Environmental Impact Analysis Process

nal Environmental Impact Statement

Volume II

High Frequency Active Aurora

FIGURE 12.4-1. UPDATED EAGLE NEST LOCATIONS AND STATUS ALONG THE COPPER RIVER

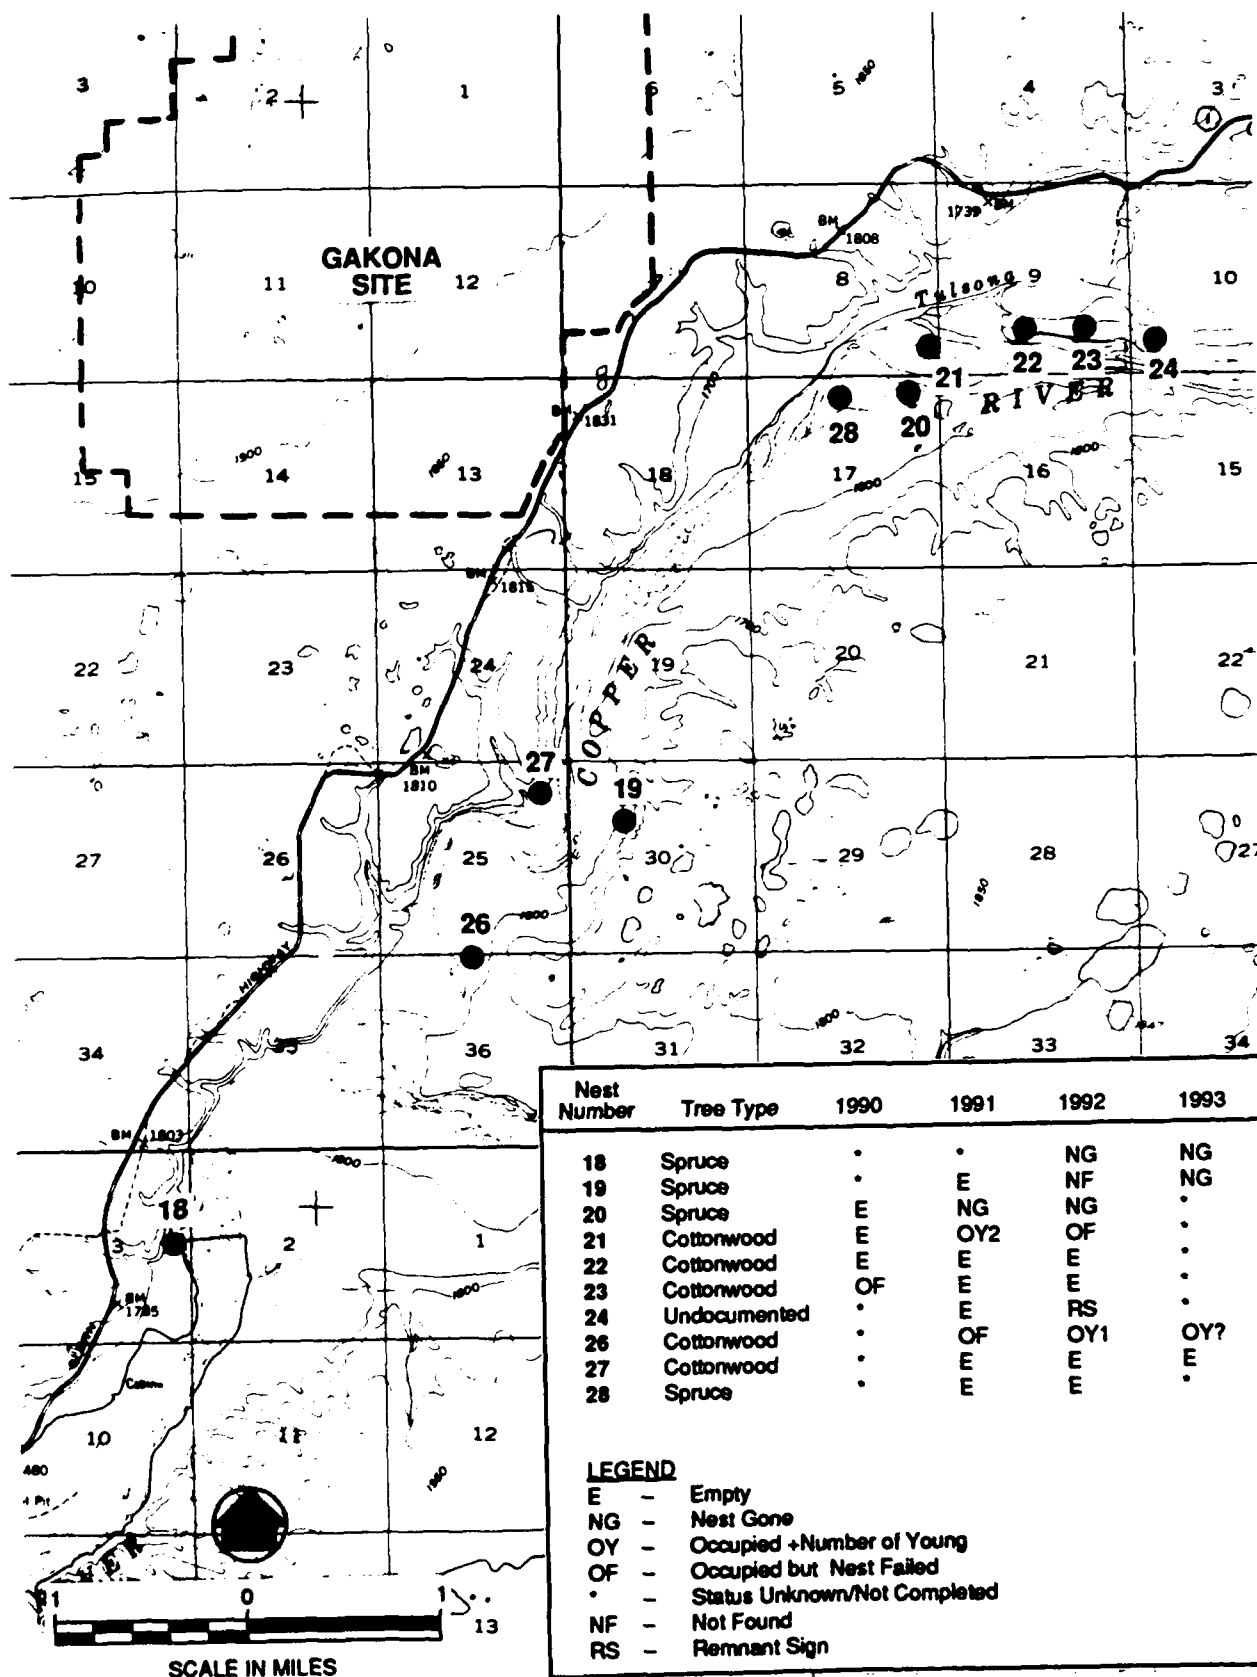
A. It is acknowledged that the information presented in the DEIS is not the most recent eagle survey data. The attached figure (Figure 12.4-1) presents the most recent information on eagle nesting in the Gakona site region. This information was presented to HAARP by the National Park Service (Wrangell-St. Elias National Park and Preserve - Mr. Russell Galipeau) in a letter dated April 26, 1993. This additional information does not change the conclusions drawn from the analysis in the DEIS. The National Park Service or the Fish and Wildlife Service will be consulted on a yearly basis during the construction period to obtain the most recent information on eagle use patterns in the potential gravel source areas.

FIGURE 12.8-2. NOISE ATTENUATION WITH DISTANCE AT THE GAKONA SITE, 120 dB(A) @ SOURCE.

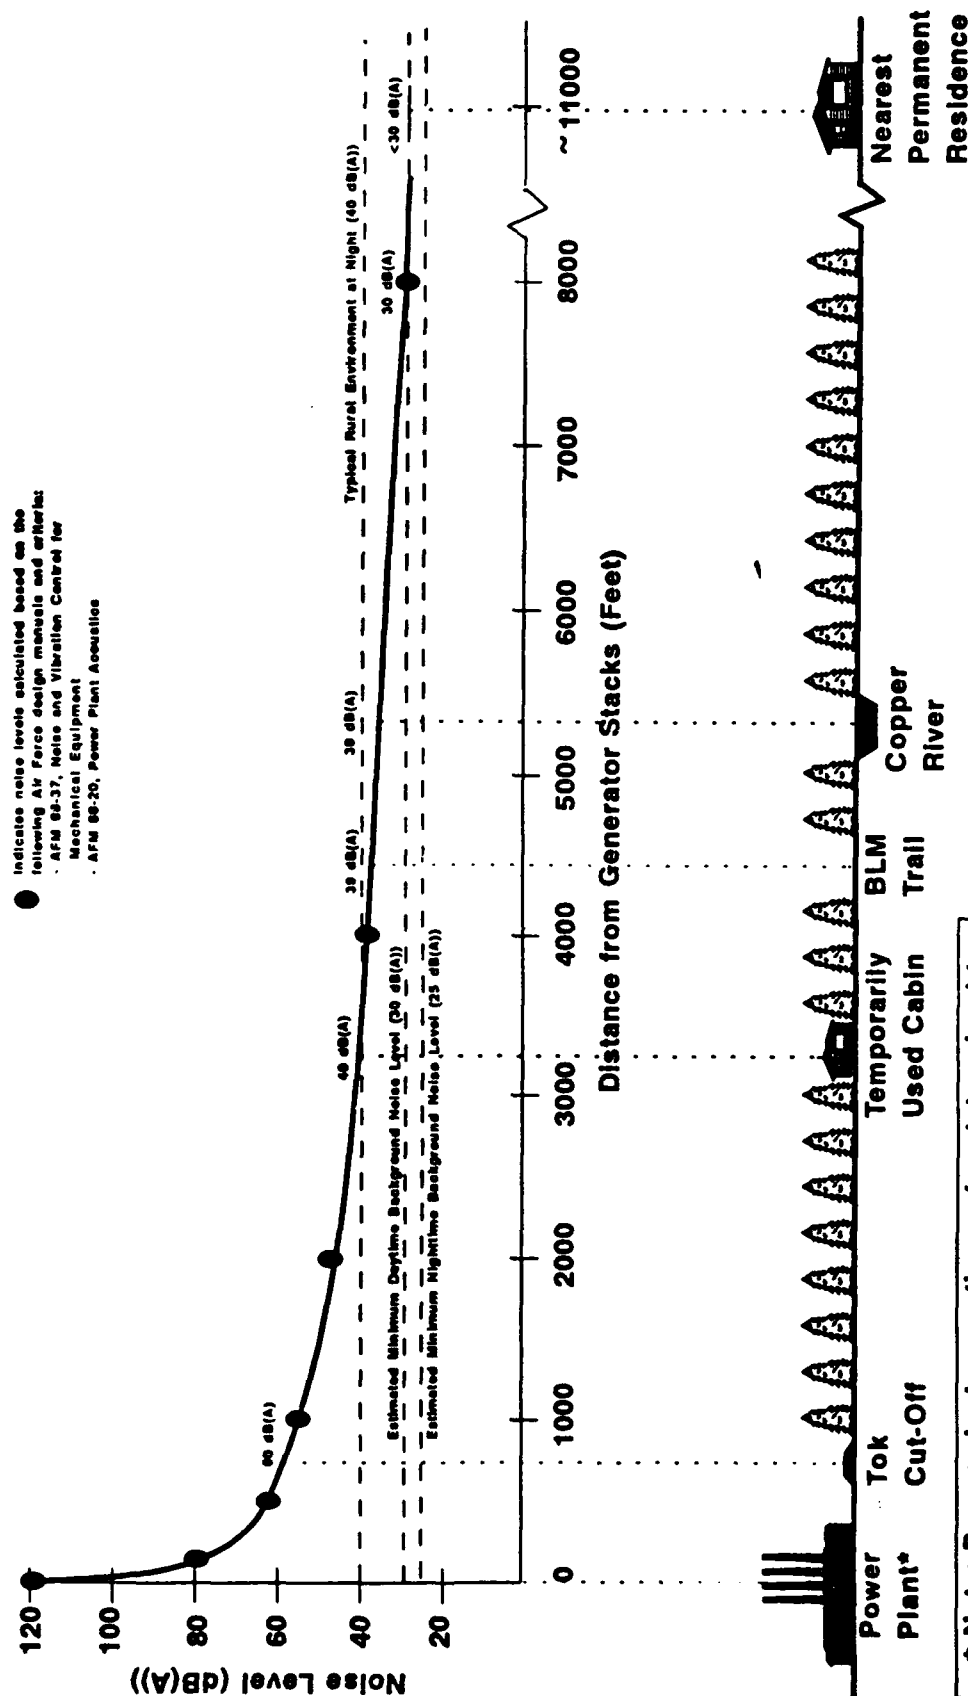
Figure 12.8-2 shows a simplified cross section of the Gakona site, showing the locations of the power plant, and several prominent features around the site, including the Tok Cut-Off, the BLM trail, the Copper River, and the nearest residences to the site. Above the cross-section is a curve which shows the way in which the sound from the generators would attenuate with distance. Note that assumptions were made regarding the forest density and attenuation effect, the temperature, humidity, and atmospheric pressure at the site, the topography (assumed flat as a worst case), and the direction of the sound. The figure indicates that, for this worst case situation with no mitigation or special mufflers on the generators, the noise would be marginally detectable under the best of sound propagation conditions at the nearest dwelling. At the Copper River distance and BLM trail distance, the noise level from the power plant would be about 38 and 39 dB(A) respectively, which is slightly less than the typical sound level from a "rural residential area at night". The value at the closest point on the Tok Cut-Off is estimated at 60 dB(A), which is equivalent to noise level in a large department store.
